Subject: SHEARON HARRIS NUCLEAR POWER PLANT, UNIT NO. 1
DOCKET NO. 50-400 / LICENSE NO. NPF-63

LICENSE RENEWAL APPLICATION, AMENDMENT 2: CHANGES
RESULTING FROM RESPONSES TO SITE AUDIT QUESTIONS
REGARDING TIME-LIMITED AGING ANALYSES

Harris Nuclear Plant License Renewal Audit Question and Response Database

Figure 1 - RHR Transient Temperature and Stress Response for Branch Component

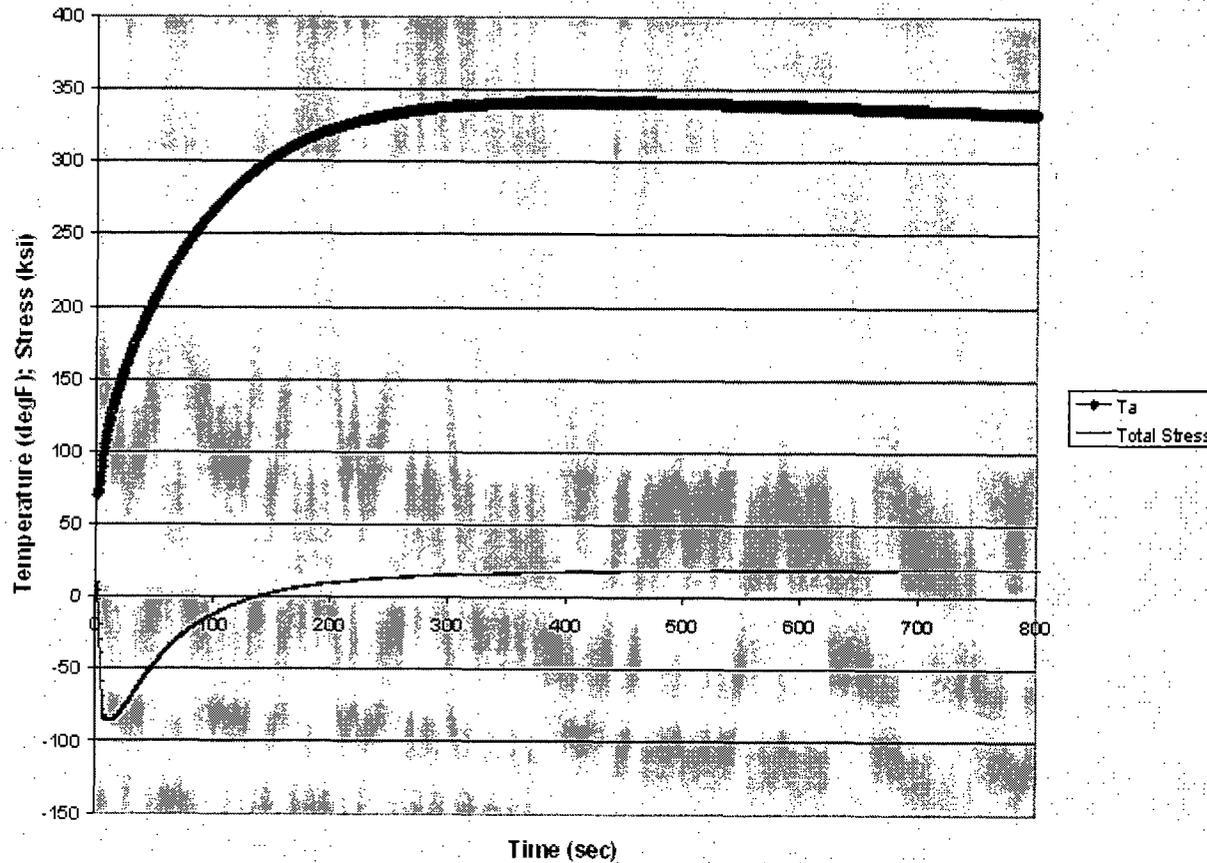
To address the question regarding the effect of the pressure and moment stresses on the total stress and resulting F_{en} , a detailed time history of the stress during the full RHR transient cycle was developed for the 12" x 1" branch component. The stresses were calculated consistent with the HNP design basis inputs and NB-3600 evaluation methodology. Applicable thermal transient, moment, and pressure histories were applied representing the RHR system design transient in the section of the RHR line containing the branch connection. The transient temperature goes from ambient conditions, at 70°F, to 350°F simulating the initiation of RHR flow through the otherwise isolated section of piping. The design transient description also assumes after the transient that gradual cooling of the system occurs at 100°F/hr, which was considered to represent negligible stress in the design. The RHR flow is initiated by design at approximately 425 psig system pressure. Therefore, a pressure load of 450 psia was used in the calculation. The moment stress from the piping design analysis of the branch was realistically ramped over the transient as a function of the pipe temperature. Pressure and moment stresses were considered only as tensile. The thermal stresses were appropriately signed to represent the inside wall stress in response to the thermal transient. The stresses were adjusted with the branch stress indices consistent with the Code analysis. The resulting stress history is illustrated in Figure 1.

This demonstrates that for the significant part of the transient history, the component is in the compressive state on the inside surface where environmental effects may be applicable. For this reason, in the initial estimation of environmental effects on this component, it was judged that environmental effect would be small and $F_{en} = 1.0$ was applied. However,

This should be applied to the usage calculated from the stress pair formed from the stress peaks represented by the minimum stress state (maximum compression) and the maximum stress state (maximum tension) of the transient. The total stress range in Figure 1 is approximately 102 ksi. Using the ASME design fatigue curve for stainless steels, this corresponds to approximately 1680 allowable cycles. For 200 design cycles of the RHR transient, the usage factor is 0.12. Applying $F_{en} = 1.15$, $U_{en} = U * F_{en} = 0.13$.

Figure B-1: Benchmark Transient.

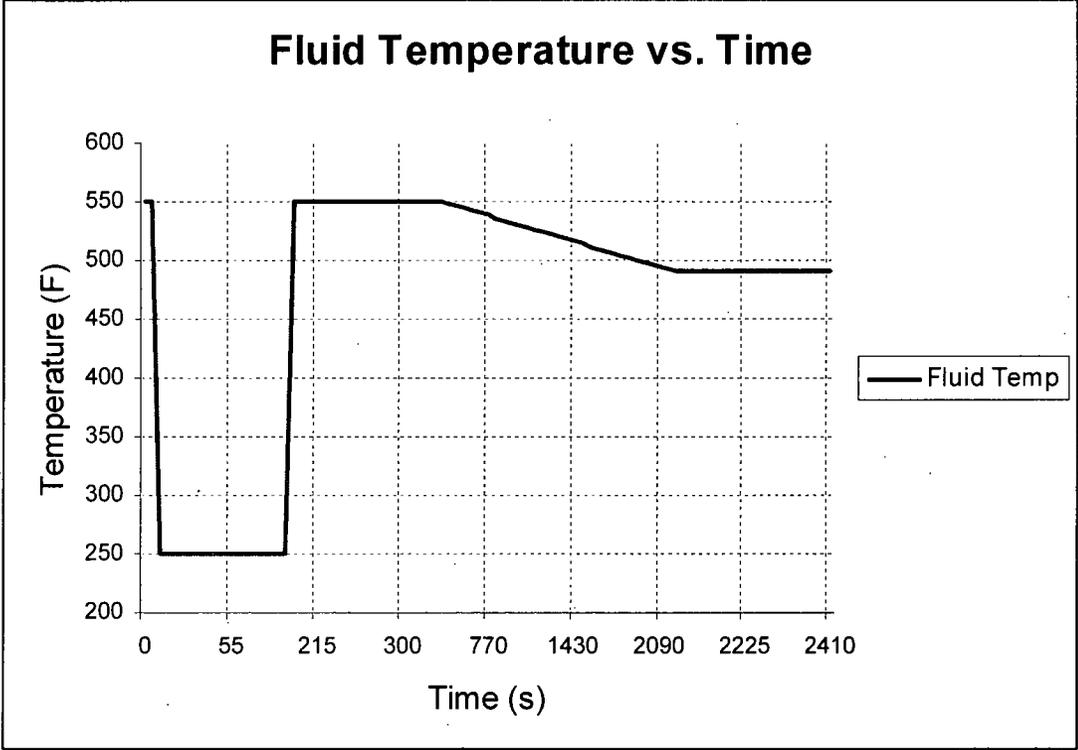
To benchmark and verify this portion of the database and determine the appropriate scaling factor for the thermal loads, an arbitrary transient was used. The transient used for this benchmarking problem is defined in the data shown in Table B-6 and Figure B-1.

In this benchmarking transient, Zone 1, Zone 2, and Zone 3 undergo a severe thermal shock. The transient considered is hypothetical but is intentionally made severe on the temperature rate so as to allow a vigorous examination of the integrity of the transfer function database. The transient is shown in the Figure B-1. This transient was analyzed by both WESTEMS™ and ANSYS. Note that the ANSYS results represent full finite element analyses whereas the WESTEMS™ results are produced by the transfer function method, which utilizes the transfer function databases produced by ANSYS.
